# Cleveland City Planning Commission

Friday, March 31, 2023

**DF2022-070** – Mazzella Lifting Technologies Signage Expansion: Seeking Final Approval

## DF2023-004 – Rock & Roll Hall of Fame Expansion: Seeking Conceptual Design

# ITEM A

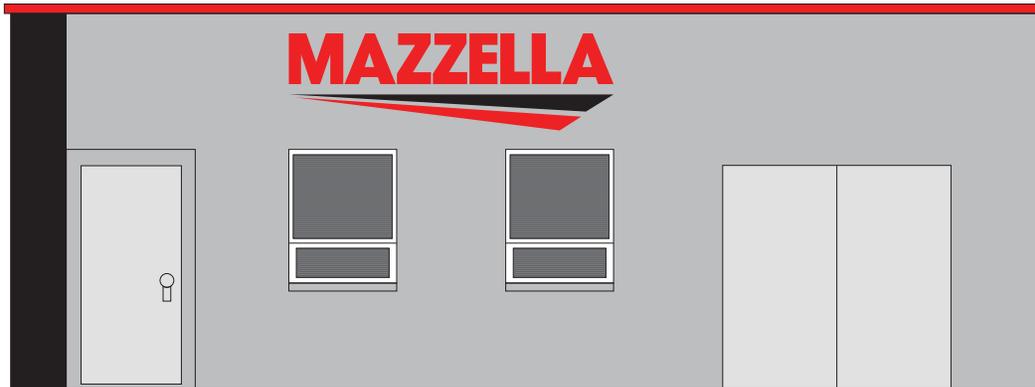
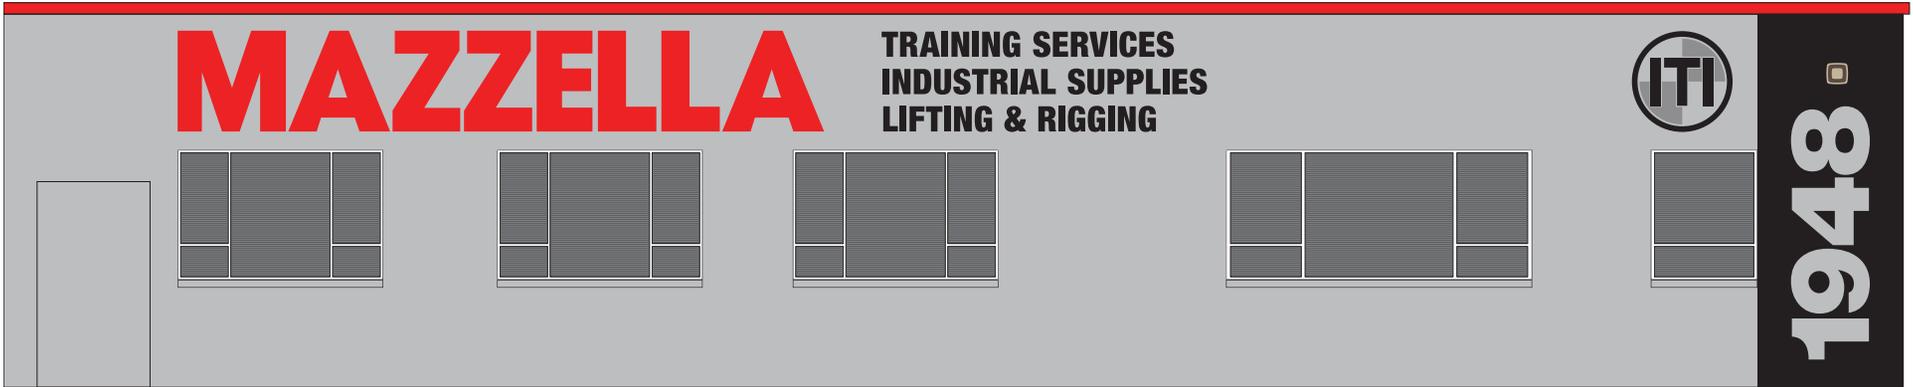
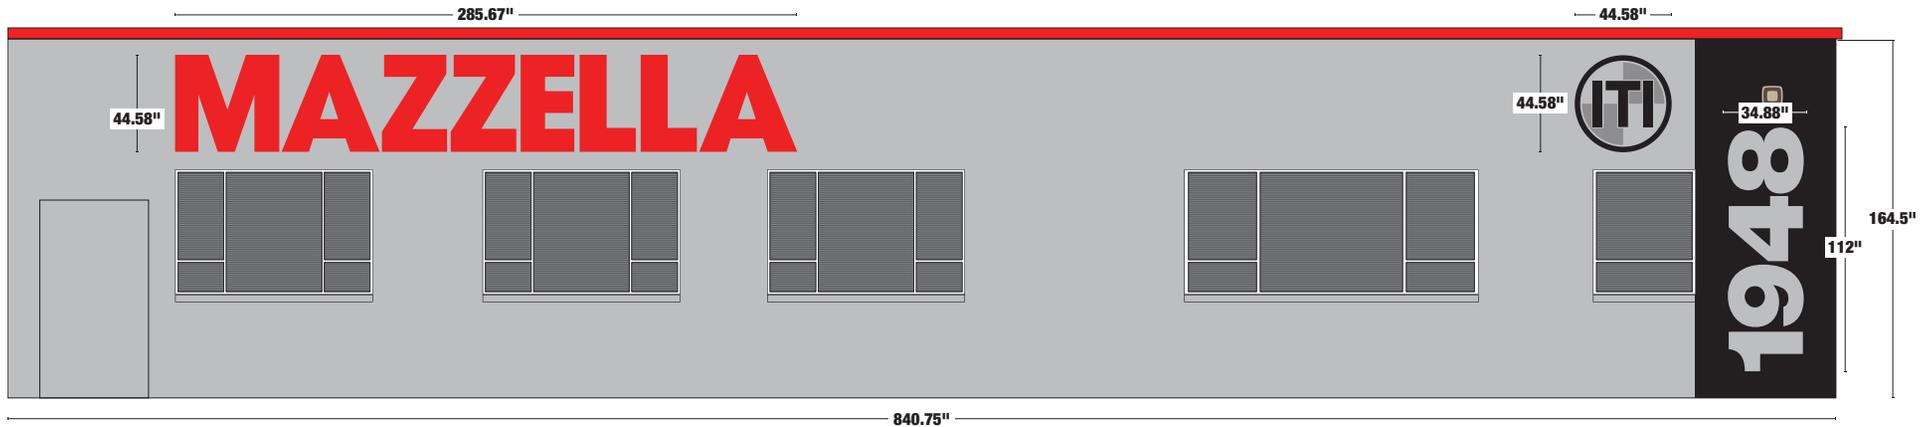
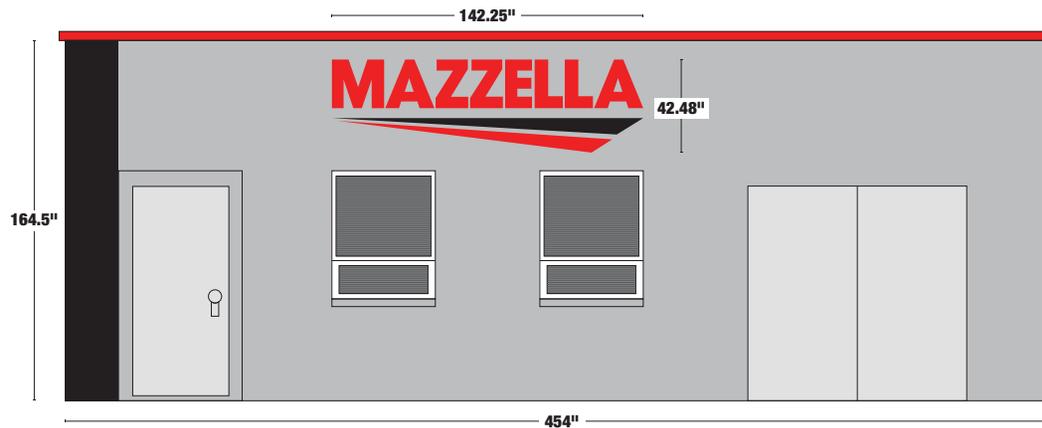
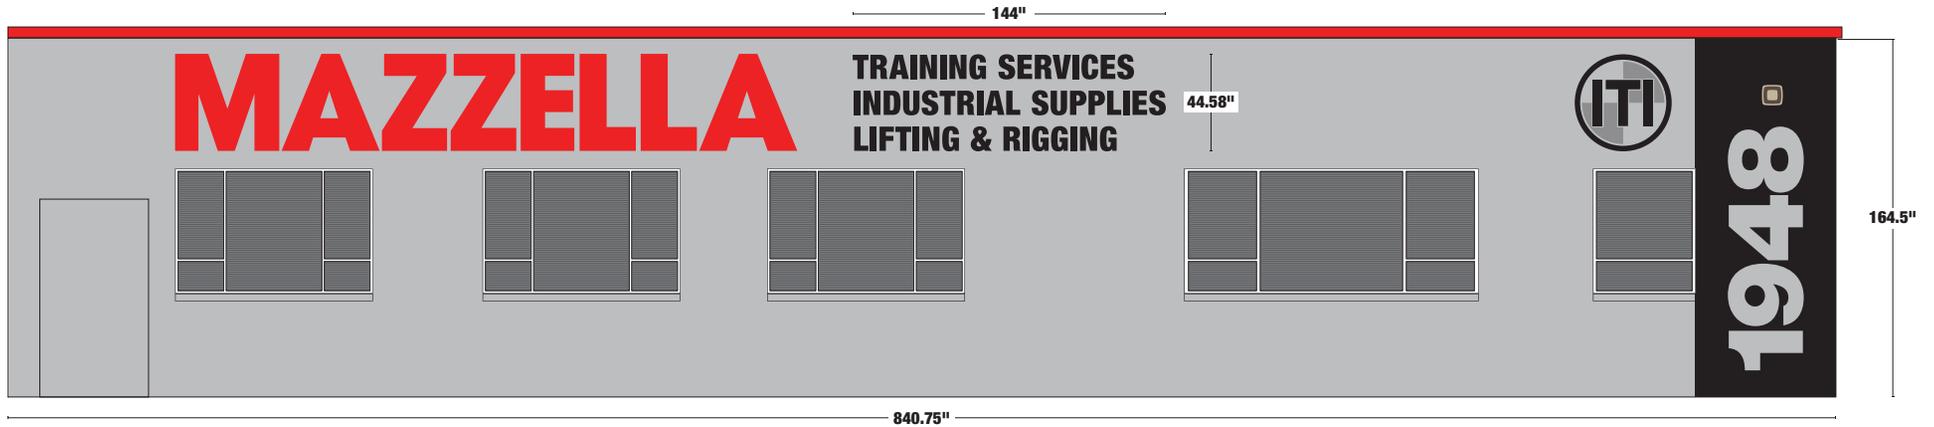
**Permission for expanding non-conforming signage: Postpone until 04/06**

- Reconsider holistic approach to signage on front facade to better conform to zoning code/square footage requirements
- Main area in question "Training Services, Industrial Supplies, Lifting & Rigging Assemblies"

**As per the recommendation of the Design Review Committee on March 16, 2023,** Mazzella is to present a version of the painted graphics that conform to existing city standards while also presenting an option that requires a variance for the “informational signage” on the front facade of the building.

The large Mazzella lettering will stay as-is on the facade of the building. The ITI logo and large address will also remain. There has been precedent set for this style of address design set forth by BrewDog, our direct neighbor.

The three lines of black text to the right of the red lettering would be painted over / removed.

The word “assemblies” would be removed to bring down the overall footprint of this area by 20 sqft (see pg 12) but making the three black lines of text smaller or moving them to the right does not visually make sense for Mazzella in this application.

## ITEM B

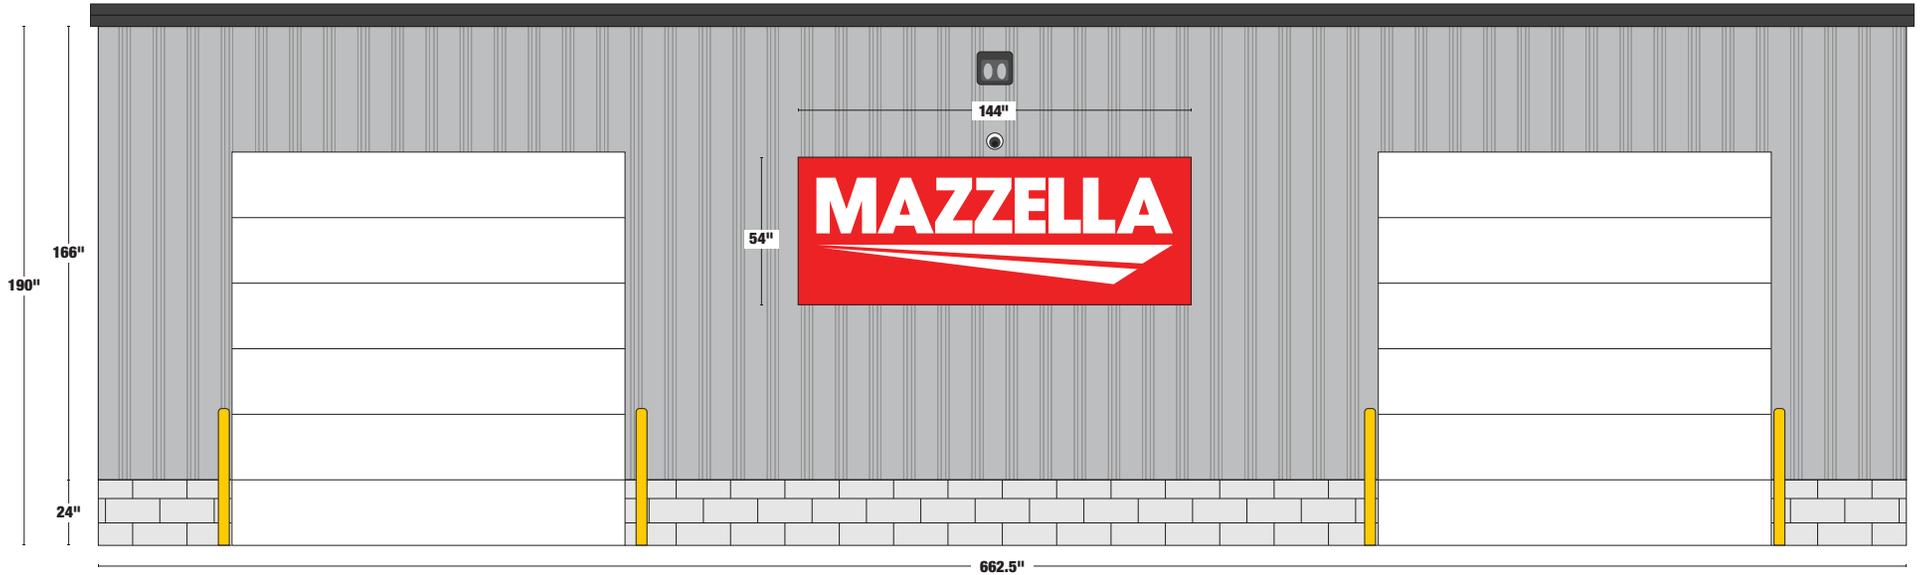
**New Signage at rear façade: Approved**

- Pending approval of additional signage listed under Motion Form for Sign Package A
- Variance required
